## Final Product/Process Change Notification

Document #:FPCN23267X

<b>Title of Change:</b>	SPM32 direct bonding copper (DBC) substrate pattern change.	
<b>Proposed First Ship date:</b>	01 Mar 2021 or earlier if approved by customer	
<b>Contact Information:</b>	Contact your local ON Semiconductor Sales Office or <a href="mailto:Daisy.Zhi@onsemi.com">Daisy.Zhi@onsemi.com</a>	
<b>PCN Samples Contact:</b>	Contact your local ON Semiconductor Sales Office or <a href="mailto:PCN.samples@onsemi.com">PCN.samples@onsemi.com</a> Sample requests are to be submitted no later than 30 days from the date of first notification, Initial PCN or Final PCN, for this change. Samples delivery timing will be subject to request date, sample quantity and special customer packing/label requirements.	
<b>Additional Reliability Data:</b>	Contact your local ON Semiconductor Sales Office or <a href="mailto:Lake.Wang@onsemi.com">Lake.Wang@onsemi.com</a>	
<b>Type of Notification:</b>	This is a Final Product/Process Change Notification (FPCN) sent to customers. FPCNs are issued 90 days prior to implementation of the change. ON Semiconductor will consider this change accepted, unless an inquiry is made in writing

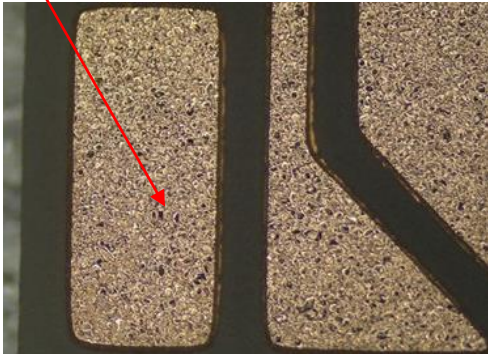
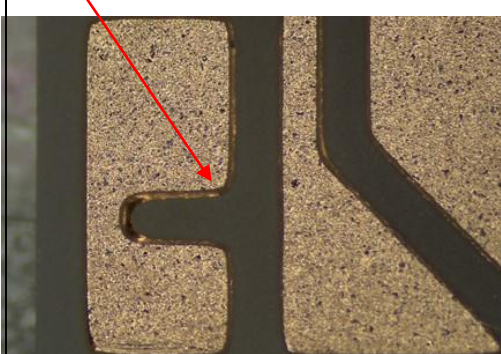
<b>Marking of Parts/ Traceability of Change:</b>	No Marking change and date code to traceability	
<b>Change Category:</b>	Assembly Change	
<b>Change Sub-Category(s):</b>	Material Change	
<b>Sites Affected:</b>		
<b>ON Semiconductor Sites</b>	<b>External Foundry/Subcon Sites</b>	
ON Semiconductor Suzhou, China	None	
<b>Description and Purpose:</b>		
DBC left bottom corner shape is rectangle in current and will change to etched in the future.		
<b>DBC pattern change</b>	<p>DBC left bottom corner shape is rectangle</p>  	<p>DBC left bottom corner shape is etched</p>
